ECE/TRANS/WP.29/GRSP/2007/2
21 February 2007

REGULATION No. 29
(Cabs of commercial vehicles)

Proposal for draft 03 series of amendments

Submitted by the expert from the International Organization of Motor Vehicle Manufacturers
(OICA)

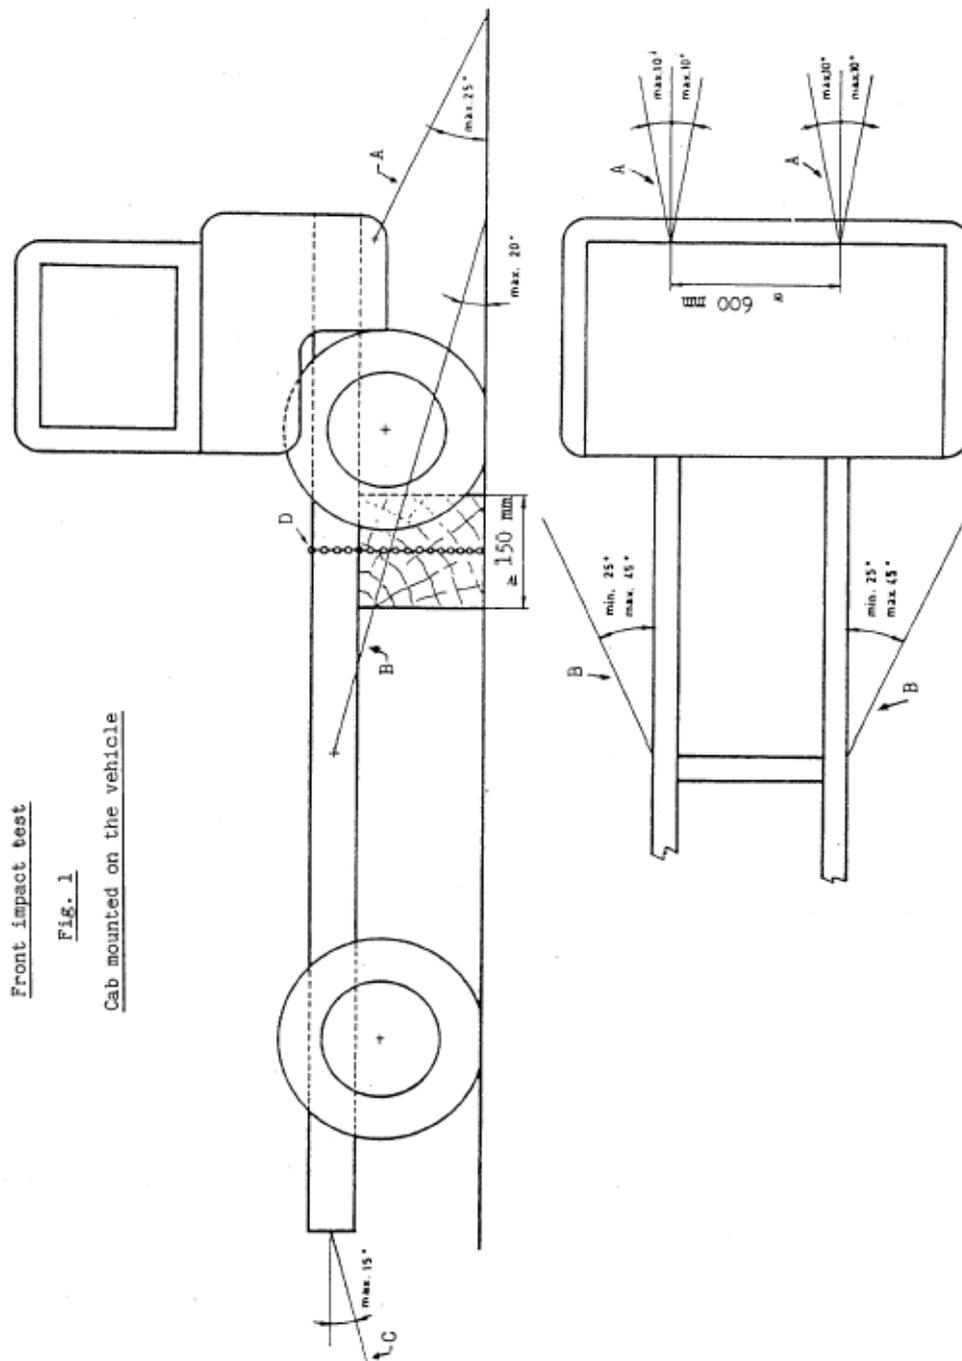
~~2. Roof strength~~

~~2.1 Cab mounted on the vehicle~~

~~Measures shall be taken to ensure that the vehicle does not shift appreciably during the test. For this purpose the hand brake shall be applied, a gear engaged and the front wheels wedged with chocks. Deformation of the various components of the suspension (springs, tires, etc.) shall be eliminated by means of rigid members.~~

~~2.2 Cab mounted on a frame~~

~~Measures shall be taken to ensure that the frame does not shift appreciably during the test.~~

~~MANIKIN TO BE USED TO VERIFY THE SURVIVAL SPACE~~

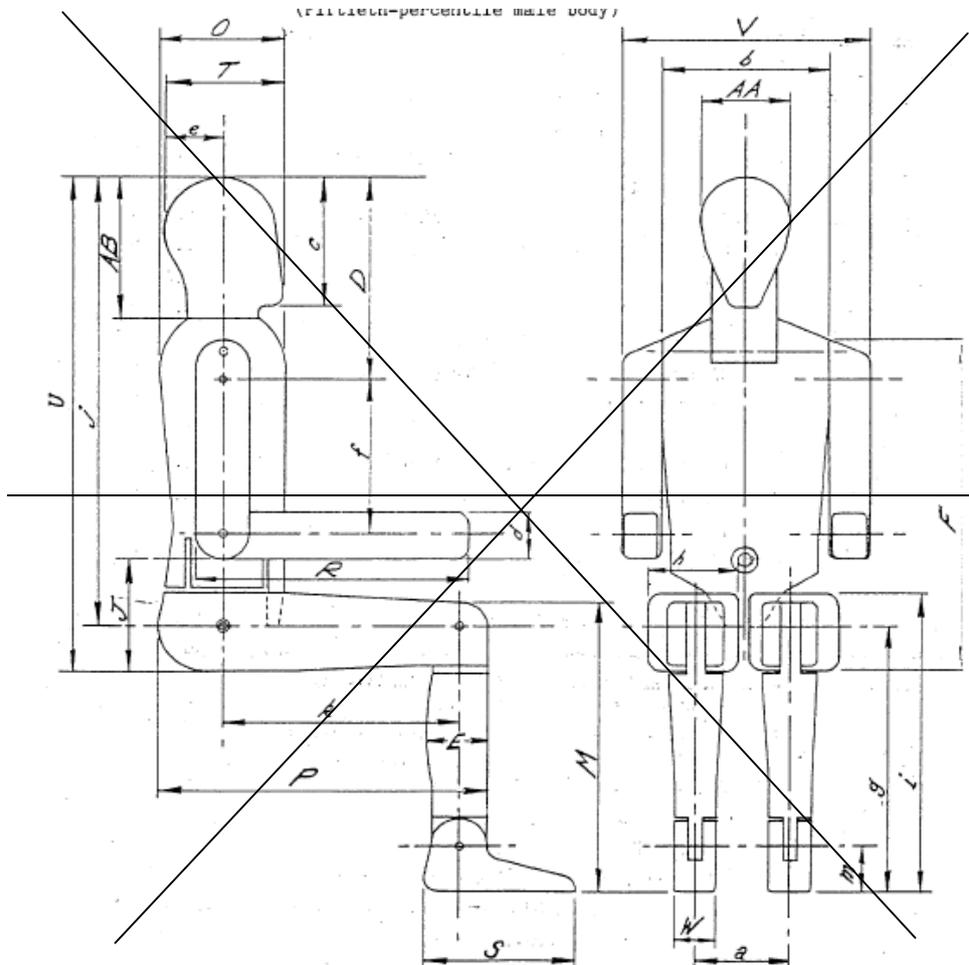
~~(Fiftieth percentile male body)~~
